Dartron

Bulletin # SB-5K-091208

SERVICE BULLETIN

Ride Name: Cliff Hanger

BULLETIN: SB-5K-091208
 RELEASE DATE: SEPTEMBER 12, 2008
 PAGE 3 OF 7

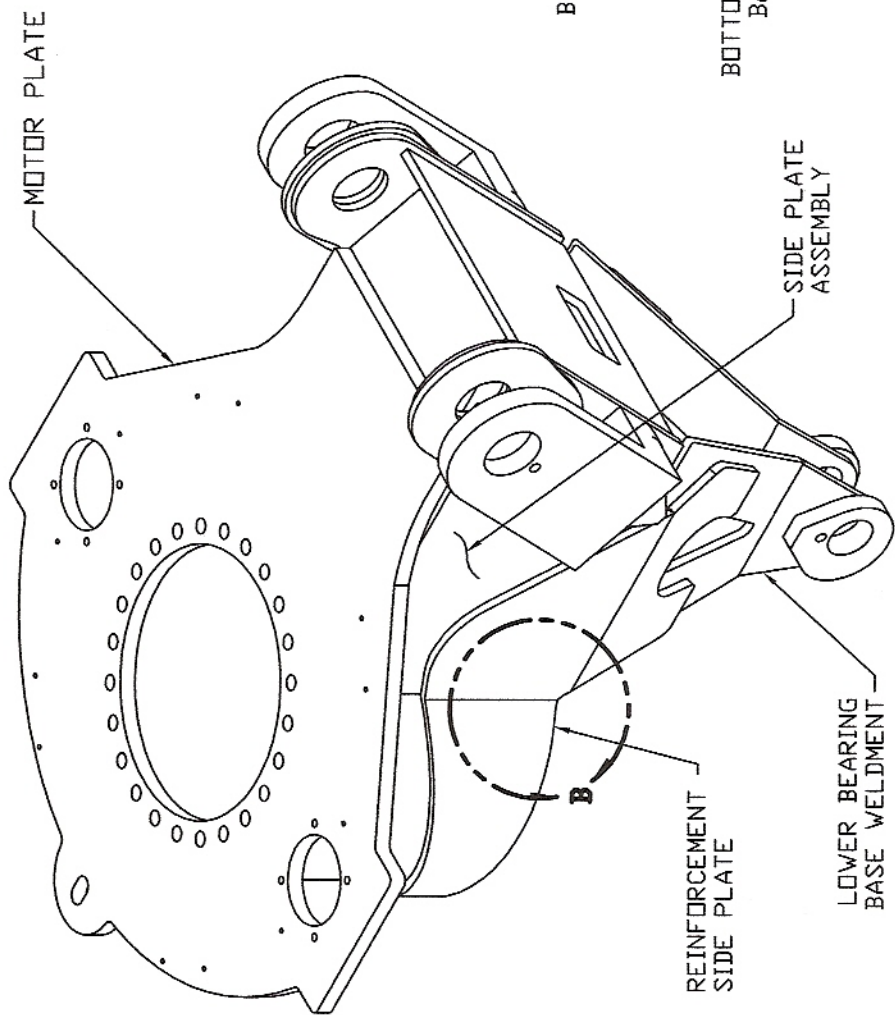
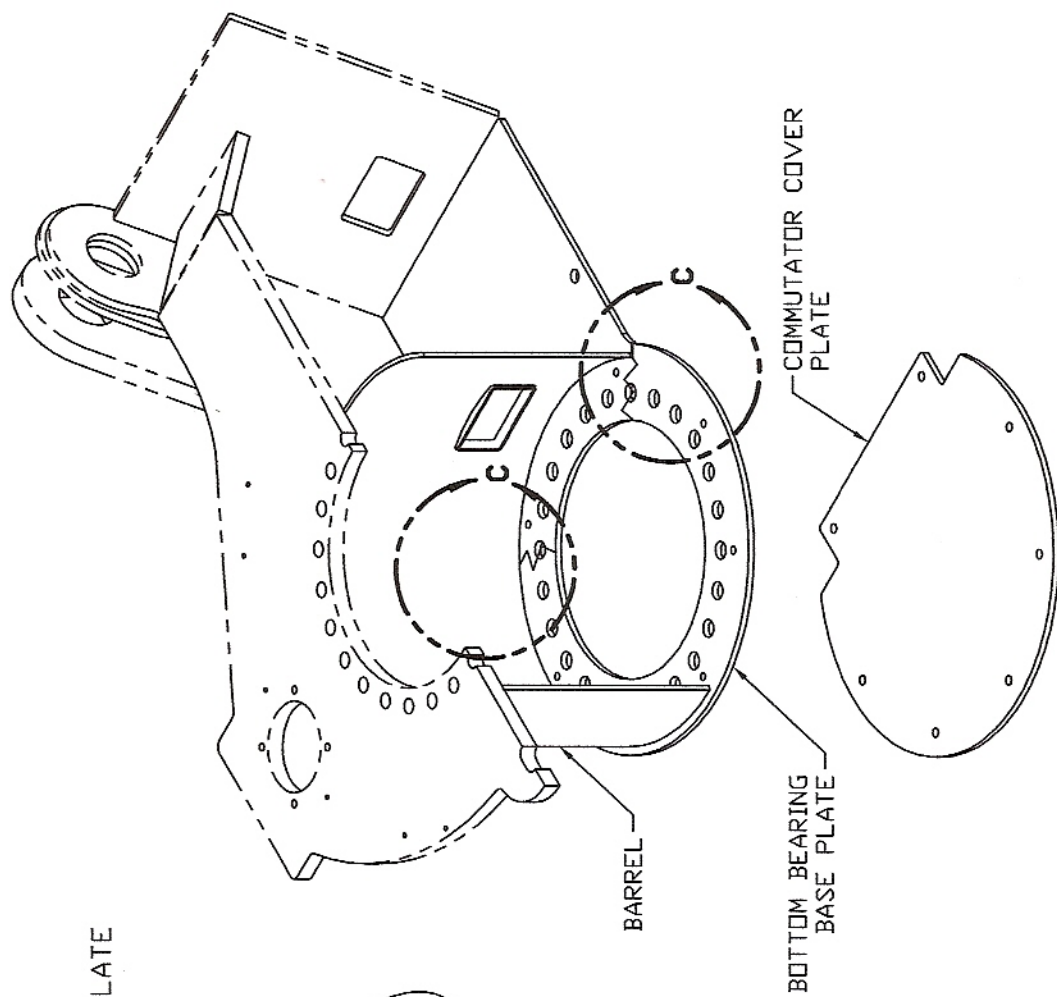
1. The ride must be set-up to perform this inspection.
2. The boom must be raised off of the boom rest pad and the Commutator Cover Plate must be removed to inspect some of these areas.
3. Five areas must be visually inspected for cracks. Those areas are shown on the drawings on pages 3 - 6 as detail areas A, B, C, D and E.
4. The areas to be inspected must be cleaned so that they are free of dirt and grease.
5. Visually inspect the location of the reinforcing plates and the associated welds as shown on pages 3 and 4.
6. Visually inspect the five areas for cracks or broken paint.
7. If broken paint is found, the paint must be removed to allow a more thorough visual crack inspection.
8. Verify the modifications to the sweep support jack assembly are per the drawing on page 7 of this bulletin.
9. If a crack is discovered please contact Dartron at 503-362-2536 to coordinate repairs.

1. A one time visual inspection must be conducted to inspect for cracks in the upper and lower bearing base as detailed below.
2. Inspect the reinforcing plates to confirm that they are installed as required by Bulletin PI-5K-003.
3. Inspect the sweep support jack to confirm that the modifications are correctly implemented as required in Bulletin SB-5K-001.
4. If cracks are found, repairs need to be completed per Dartron Specified procedures and Dartron must be notified.
